20 September 2019

**Our Ref:** 19-098

**RE: S4.55(2) MODIFICATION APPLICATION TO SSD 17\_8667 IN RELATION TO THE GOULBURN BASE HOSPITAL REDEVELOPMENT (130 GOLDSMITH STREET, GOULBURN)**

Figure 2: Comparison of approved vs proposed scheme (Source: Silver Thomas Hanley)

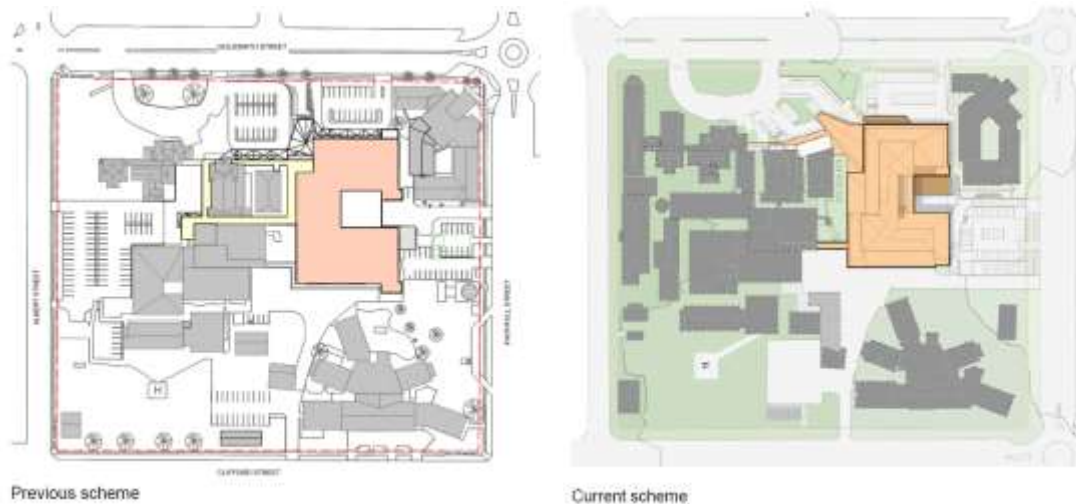
- The revised built form, incorporates a similar building envelope and footprint, retaining the approved "u-shape" envelope as the approved (refer to Figure 2), with a reduced GFA and overall height, thereby improving shadowing and visual massing impacts to the surrounding environment, which will be discussed further in Section 3.1.5 of this Statement. The modifications to the built form ultimately seek to improve the functionality of the building and the relationship of the building with adjacent areas and buildings within the hospital campus.

Figure 3: Sections comparison (Source: Silver Thomas Hanley, 2019)

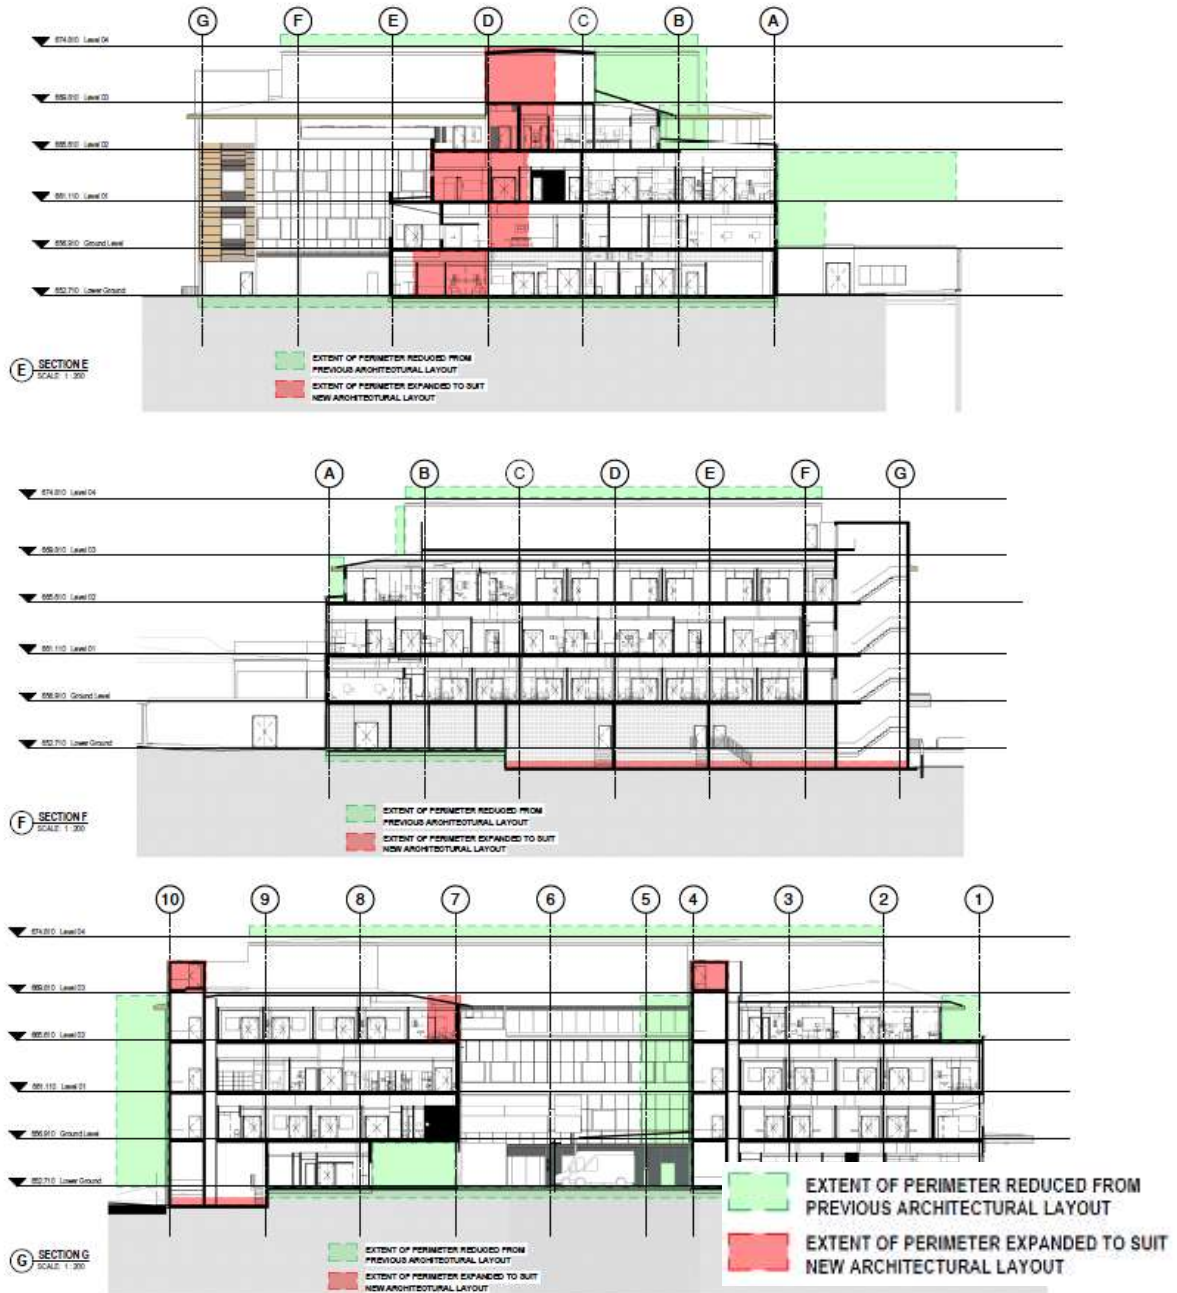
Figure 3 illustrates a comparison of the proposed modifications to the built form, which has ultimately decreased the height and GFA of the approved built form.

The form of the building has been simplified and incorporates parapeted and low-pitched roof forms which reduces the overall height by 800mm, to 21.285 metres, reflecting and complementing the character of the heritage buildings on the site and within the surrounding conservation area. Whilst the building comprises four storeys, the proposed lower ground level of the amended building is below the ground level of existing buildings and upper levels of the building have been setback to reduce the apparent bulk and scale of the structure. Darker recessive colours and “lighter” building materials are also proposed for the upper levels, when compared to the approved development (refer to Figure 4) to again break up the overall massing of the building and provide a more sympathetic built form outcome on the site.

Figure 5: Site Plan Comparison

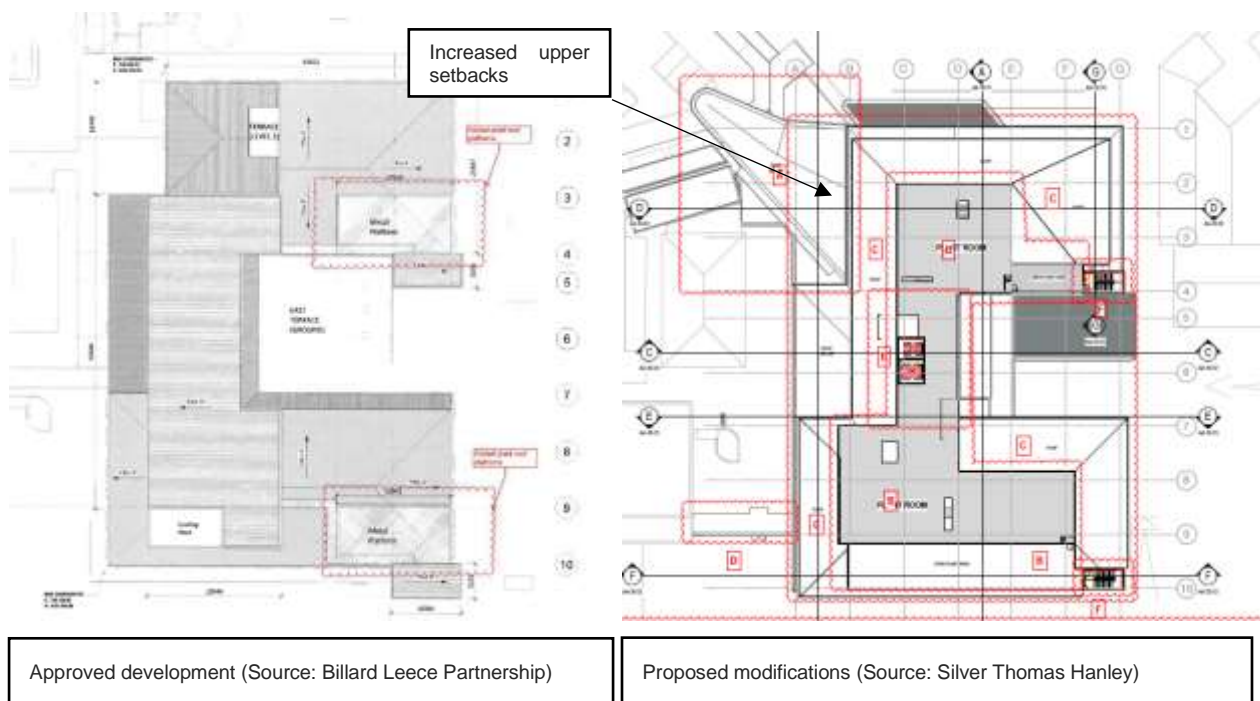
The amendments also propose to retain existing building #32 (“pathology/specimen/collection building”) as shown on the architectural plans at Appendix 1, as it was previously approved to be demolished. This assists to realign the main entry point and provide a more direct visual and physical connection to the lift core and vertical circulation in the new building, whilst improving the site’s relationship with the surrounding heritage buildings.

Both level three and level four of the new building are setback from the lower levels to reduce visual massing (refer to Figure 5). This further allows the building envelope to blend with the existing hospital buildings. The main entry also provides a better definition of this key access point.

Figure 7: Proposed modifications to landscape plans (Source: Space Lab)

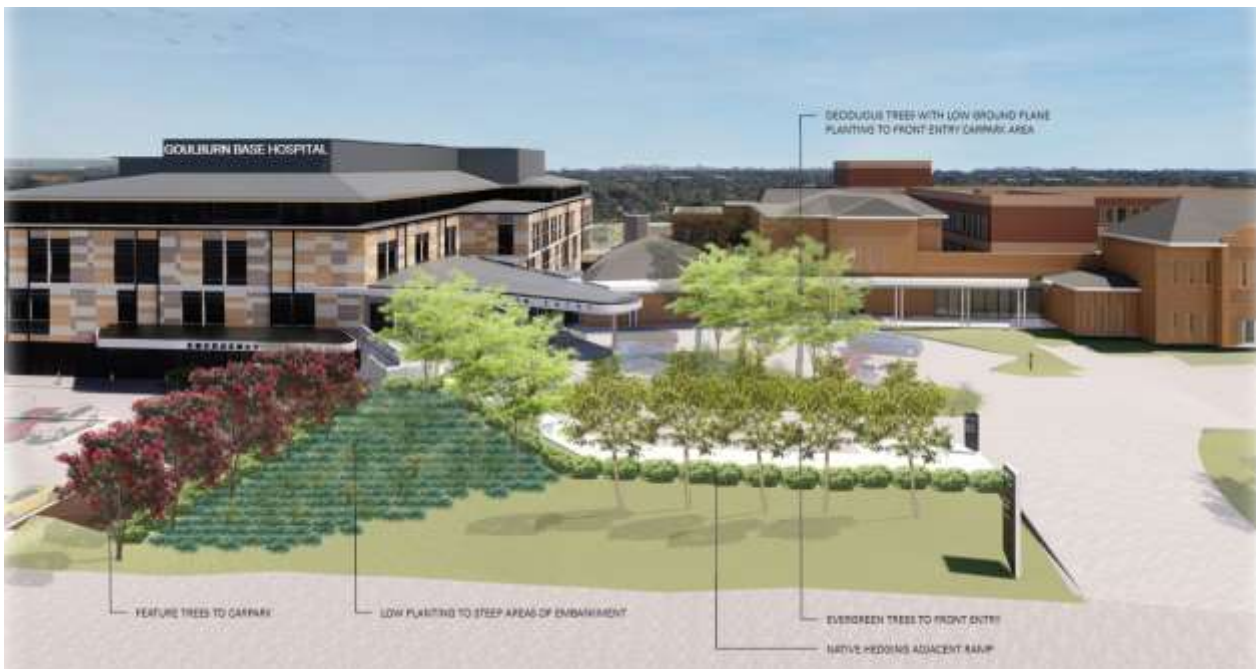
Space Lab has prepared amended landscape plans (Appendix 10) to accommodate the modified building envelope and footprint. The modified plans provide suitable landscaping to the boundary of the hospital

(refer to Figure 7), providing a buffer to adjacent residential areas. Appropriate plantings have been proposed, including hedging, screening and evergreen plant species, to complement the character of the area

The proposed modifications to the approved landscape design will also improve and soften the development when viewed from the site's street frontages yet allow continued views along both streetscapes.
